# Naval Submarine Medical Research Laboratory

NSMRL/F2108/TM—2022-1402

Recalculation of Carbon Dioxide Scrubbing Capacity of Battelle Curtains: Implications for  
Distressed Submarine Survivability Lithium Hydroxide Load Out Requirements

Addendum to NSMRL Technical Reports No. 1228 of 27 August 2003 No. TR--2009-1270  
of 12 August 2009

**Figure 1.** Copy of Figure 3 from reference (2). RPC = Reactive Plastic Curtain (Micropore ExtendAir Sheets); BC = Battelle Curtains.

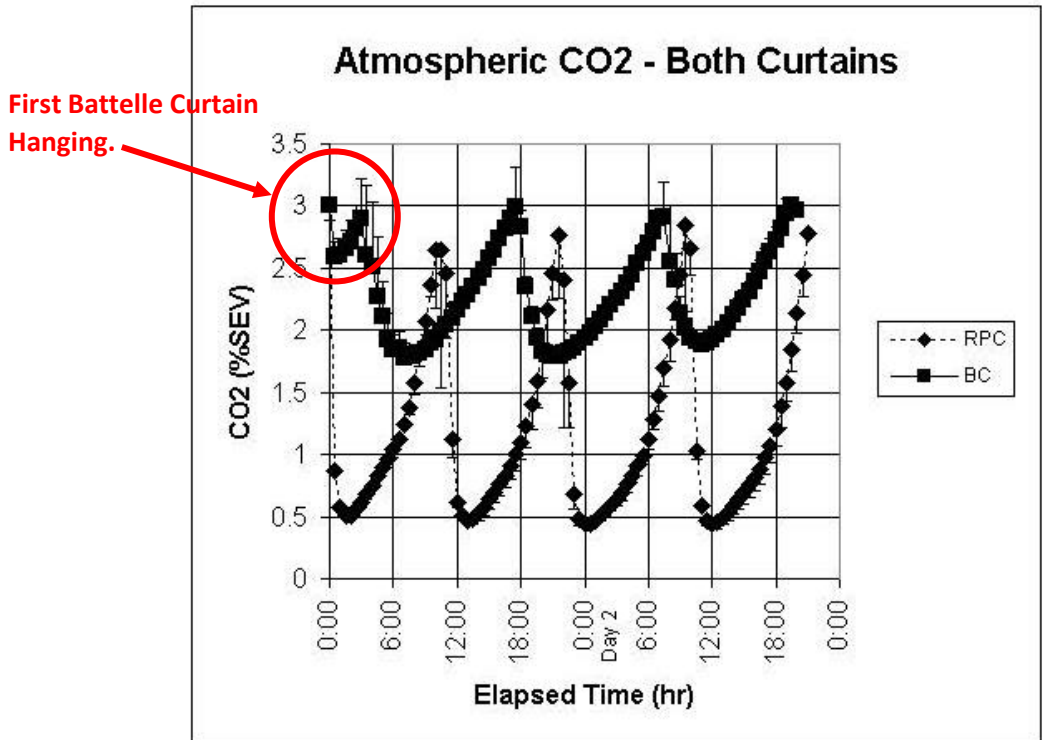
Paragraph 4 of NSWCPD comments, Appendix (A) observes that the first hanging of Battelle Curtains in each of the four test runs of the NSMRL test of Battelle Curtains and Micropore ExtendAir Sheets, reference (d), appeared to reach “exhaustion” in only three hours. Figure 3 from reference (d) is copied below. The three other hangings of Battelle Curtains did not reach “exhaustion” for approximately 12 hours. NSMRL reference (d) noted the short duration of the first hanging in the Results section (page 9) but did not comment on the possible cause, despite the fact that the short time to exhaustion was observed during each of the four trials in the experiment. Reference (2) stated:

NSWCPD Appendix (A) speculates that the cause may have been low relative humidity in the test chamber at the start of each experiment trial. Based on reference (2) that speculation is probably not correct as the NSMRL reference (2) report states, “The mean minimum RH (Relative Humidity) observed with the BC was 98.5%, with a range of 96% -100%.” (page 13)

Navy Research Laboratory (NRL) testing in reference (6) confirms that CO<sub>2</sub> absorption performance by LiOH relies on the presence of water vapor and at relative humidity below 20% CO<sub>2</sub> absorption efficiency drops to below 50% of theoretical capacity. The Results section of reference (h) also indicates that at very high relative humidity (>85%), the efficiency of LiOH absorption of CO<sub>2</sub> drops. Reference (6) reported CO<sub>2</sub> absorption efficiency (% of theoretical capacity) as 16% at >95 % relative humidity. Below is Table 2 from reference (6) and a graph (Fig 3) constructed from those data. Reference (2) reported that in all hangings of all experiments, the relative humidity at the conclusion of each hanging was 100%. The high relative humidity may have slowed the reaction rate and reduced the effectiveness of the curtains in the first hanging and hastened the end of the trial run by allowing CO<sub>2</sub> to return to the 3% level sooner than would have occurred if relative humidity had stayed below 95%. The Lock-in and Lock-out of the divers to hang the next set of Battelle curtains may have introduced enough dry air so that the curtains could resume reacting and then assisted the second hanging in scrubbing CO<sub>2</sub>. We believe the comment from NSWCPD Appendix (A) concerning the lack of sufficient relative humidity as the cause for the short time to “exhaustion” of the first hangings is incorrect. In fact, it is more likely that the exact opposite occurred and the initially

high, and then increasing, relative humidity may have caused a slowing of the absorption reaction and allowed CO<sub>2</sub> to build up to the 3% level faster than expected.

Figure 4. Copy of Figure 9 from NSMRL reference (2).

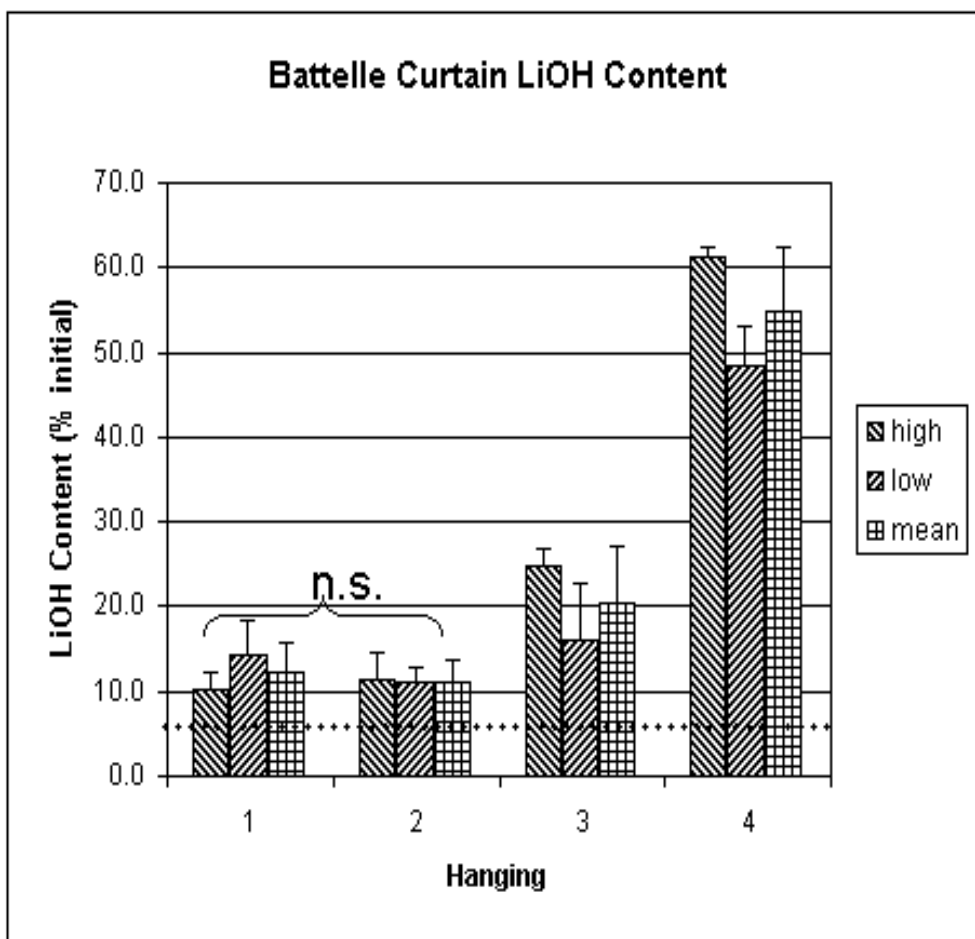
The author of NSWCPD Appendix (A) questioned the calculations performed in NSMRL reference (2) that combined the average of the remaining unreacted LiOH from all four hangings (which included hangings three and four that had significant unreacted LiOH at the termination of the experiment) to determine the “scrubbing

capacity” of the Battelle Curtains. If only hangings one and two are considered to have reached total exhaustion, then the author of NSWCPD Appendix (A) calculates that the “scrubbing capacity” of the Battelle Curtains is approximately 0.83 lbs CO<sub>2</sub> / lbs LiOH as opposed to the NSMRL reported 0.756 lbs CO<sub>2</sub> / lbs LiOH. The 0.83 lbs CO<sub>2</sub> / lbs LiOH value is very close to the original 0.85 lbs CO<sub>2</sub> / lbs LiOH implemented by the NAVSEA 05Z Technical Warrant Holder (TWH) in 2010 and reflected in the text of reference (4) and the number of LiOH Canisters loaded onboard Los Angeles Class (SSN 688) submarines. Based on this reevaluation of results, we believe that the original value of 0.85 lbs CO<sub>2</sub> absorbed per pound of LiOH value is sufficiently accurate and that the cost and effort involved in approving and issuing the subject A&I (Partial Replacement of Granular LiOH with Micropore ExtendAir sheets), reference (a), is not warranted. Additionally, if approved, the change in load out of LiOH on the Los Angeles Class would immediately generate the need for an additional revision to the Guard Book to account for the two types of CO<sub>2</sub> absorption products onboard. This document is to be considered a change to final results of NSMRL Technical Report 1288, reference (2). The work of Appendices (A) and (B) indicate that additional testing should be conducted to validate the value for CO<sub>2</sub> absorption by LiOH supplied by the U.S. Navy Supply System. It is suggested that NSMRL conduct an additional set of tests using both the Battelle Curtains and Micropore ExtendAir sheets in a larger test facility (e.g. the Navy Experimental Dive Unit Ocean Simulation Facility “Wet pot.” At approximately 7,100 ft<sup>3</sup> (201.0 m<sup>3</sup>) as compared to the 700 ft<sup>3</sup> (19.8 m<sup>3</sup>) for the inner lock plus 510 ft<sup>3</sup> (14.4 m<sup>3</sup>) for the outer lock available in the NSMRL Genesis Chamber) to more closely approximate the volume of the forward compartment of a Los Angeles Class SSN and extend the test duration to seven days. That test would also provide data on the shape of the compartment CO<sub>2</sub> content curves as the curtains become exhausted. At present, survivors are directed to linearly extend the compartment CO<sub>2</sub> content curve to determine time to start escapes. Based on the results shown in reference (2) and the fact that reference (3) testing did not exceed 96 hours, current Guard book guidance may be insufficient to ensure that all survivors have escaped prior to compartment CO<sub>2</sub> content reaching 6% SEV.

Figure 6. Copy of Figure 7 from NSMRL reference (3)

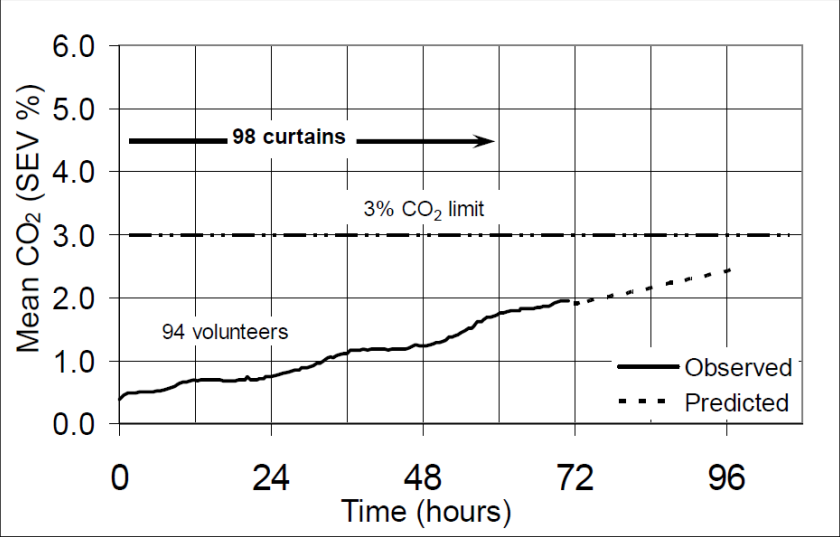
- a. We also believe that the high relative humidity conditions established during reference (2) testing resulted in shorter times to exhaustion than could have been achieved in a more moderate relative humidity environment. By comparison, during SURVIVEX 2003, the relative humidity levels began at approximately 51% and the exercise terminated at 72 hours with relative humidity at 65% (the

highest relative humidity reached was 70% at 64 hours.). The Battelle Curtains appeared to function as desired as CO<sub>2</sub> was maintained below 2% for the 72 hours of the experiment using 98 Battelle Curtains with 94 “Survivors” in the forward compartment. On the USS Salt Lake City in SURVIVEX 2004 the relative humidity varied from 58% at the start of the experiment and increased to 85% which, when combined with the increased temperature in the compartment, resulted in termination of the experiment due to concerns with heat stress injuries to the “Survivors” at 96 hours. Figures 7, 9, and 24 of reference (3) are copied below to illustrate the CO<sub>2</sub> levels and relative humidity during the experiments.

Figure 9. Copy of Figure 9 from NSMRL reference (3)

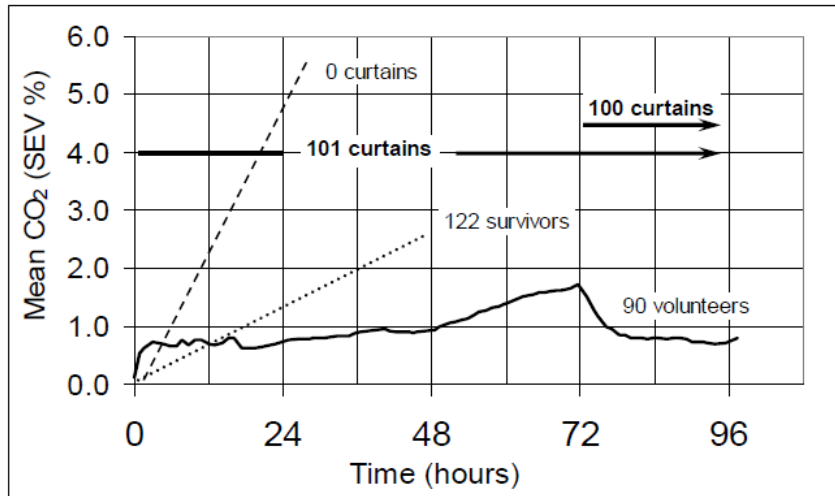
As in SURIVEX 2003, the Battelle Curtains in SURIVEX 2004 maintained CO<sub>2</sub> below 2% for the entire experiment. We believe the curtains functioned better than in the initial experiment of NSMRL reference (d) due to the lower relative humidity. If the NSMRL reference (d) experiment were repeated today, we recommend starting with relative humidity at 50% and allowing it to increase “naturally” through the reaction of the LiOH. Additionally, all curtains to be tested in a further experiment should be hung at the start of the trial to match the current guidance to DISSUB survivors to hang all available LiOH curtains at the start of the DISSUB casualty period to minimize generation of CO<sub>2</sub> during a second filling and hanging process (and to utilize the available strength and energy of the survivors at the start of the DISSUB period. Both are expected to decrease over the DISSUB period while awaiting rescue). We would also change the initial starting CO<sub>2</sub> level to 0.5% and then add CO<sub>2</sub> to the test chamber based on the expected metabolic production rate for the simulated number of survivors. The real missing information at this point that would be gained from another test of Battelle Curtains is the shape of the atmospheric CO<sub>2</sub> concentration curve as the LiOH is exhausted. At present, DISSUB survivors are directed to linearly extend the CO<sub>2</sub> concentration curve and estimate when it will reach 6% and then to subtract the time it will take to escape all Fit Survivors (at eight personnel escaping per hour) to determine the actual time to begin escapes. If the curve is not as linear as depicted in figures 6 and 8 above, then the guidance to survivors must be adjusted to account for a non-linear increase in CO<sub>2</sub> level.

Figure 3. Chamber atmospheric CO<sub>2</sub> content throughout the course of experiments with the BC and the RPC. Each point depicts the mean of the data from four experiments. Error bars depict 1SD.

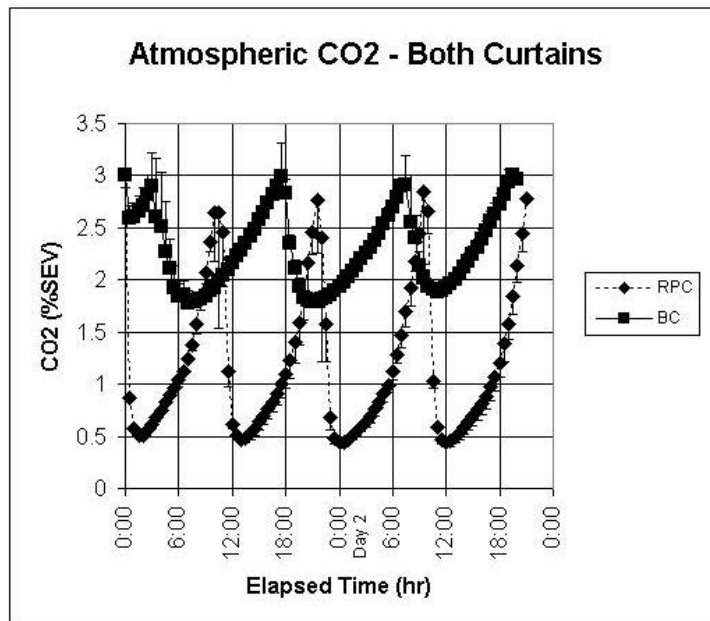
5. The results for the first hanging was peculiar as the time for the chamber CO<sub>2</sub> to return to 3% was only a little over 3 hours. This occurred in each of the four trials. Although reference

(c) noted the unusually short time, no further discussion of it appeared. It may be possible that the lower humidity in the chamber at the beginning of each test may have limited the reaction rate of the first hanging. The availability of water vapor plays an important function in the actual reaction of the LiOH capturing the CO<sub>2</sub>, reference (d). The chamber was initially started at 85% RH and 26.1°C, and subsequently rose in both temperature and RH (~98%RH on average) with each hanging. At the higher temperatures, the increased RH represents significantly more available water vapor. It is not certain that this available water vapor can explain the unusually slow rate of CO<sub>2</sub> absorption by hanging 1. Reference (d) reports that humidities above 80%RH should be adequate for LiOH absorption. (The data for that comes from reference (d) only for 25°C while the NSMRL tests, reference (c) reached 31°C by the fourth hanging.)

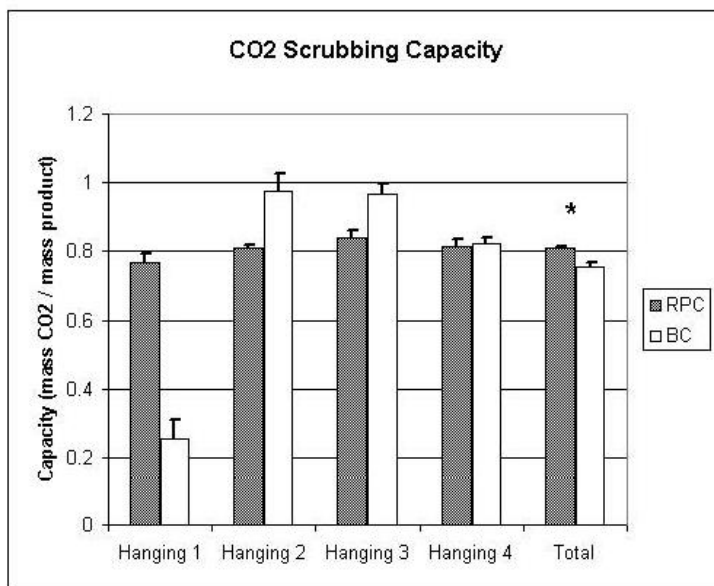
6. The calculated capacity of each set of curtains was computed as the “exhaustion time” multiplied by the flow of CO<sub>2</sub>. The “capacity” of the Battelle curtain / granular LiOH results were presented in reference (c) as Figure 5 shown below. (The Battelle curtains / granular LiOH are the open columns in the figure below.) The average of these hanging capacities is indeed 0.756 lb CO<sub>2</sub> / lb LiOH.

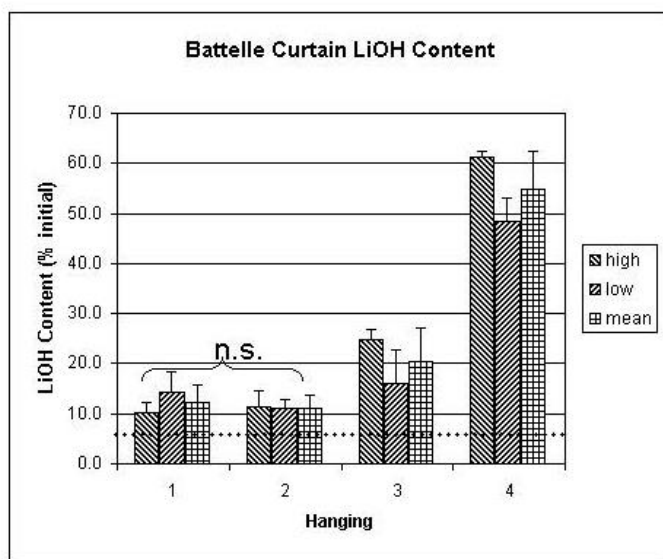
7. However, at the end of the four hangings in a row of each test, the LiOH material was assayed for unreacted LiOH. That data gives the final unreacted capacity of each of the four hangings which had been exposed for different lengths of time. The final unreacted LiOH in each set of Battelle curtains was presented as Figure 9, shown below. That figure clearly shows that although the first hanging performed dismally based on initial exposure time it reached approximately 90% of its theoretical capacity or 0.83 lb. CO<sub>2</sub> / lb. LiOH in the approximately 44 total hours of exposure. Reference (c) Figure 9 also shows that the second hanging also reached approximately the same final usage in approximately 34 hours. The “scrubbing capacity” given by reference (c) included both the poor performance of the first hanging and the less than fully consumed third and fourth hangings which clearly have additional absorbing capacity.

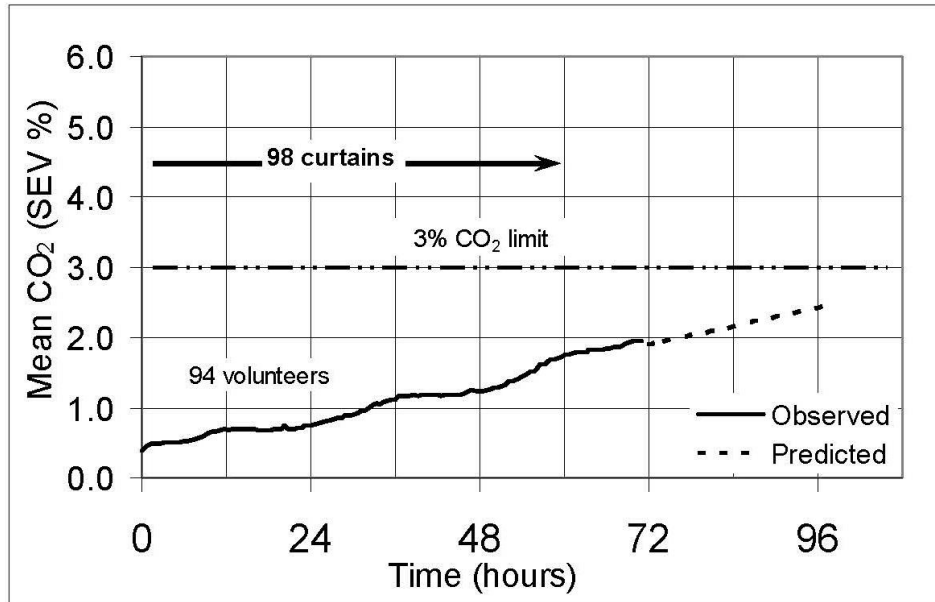
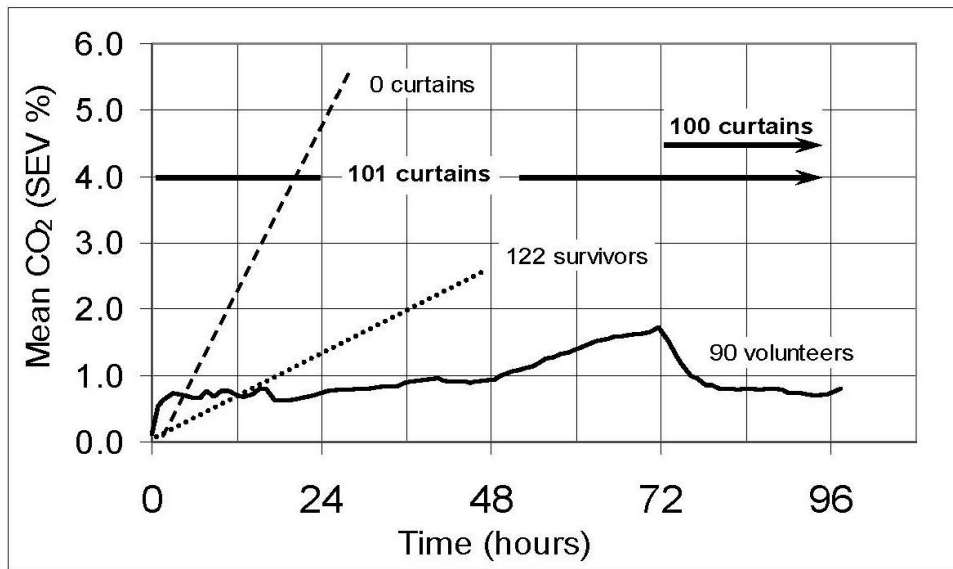
5. The important data from the two Survivex tests were reported as figures 7 and 9 of reference (c) reproduced below. Knowing the volume of the compartment, number of survivors, CO<sub>2</sub> productions rate, starting and final CO<sub>2</sub> concentration and time, the mass of CO<sub>2</sub> absorbed by the LiOH. With the additional knowledge of the mass of LiOH deployed, the capacity per pound can be calculated.
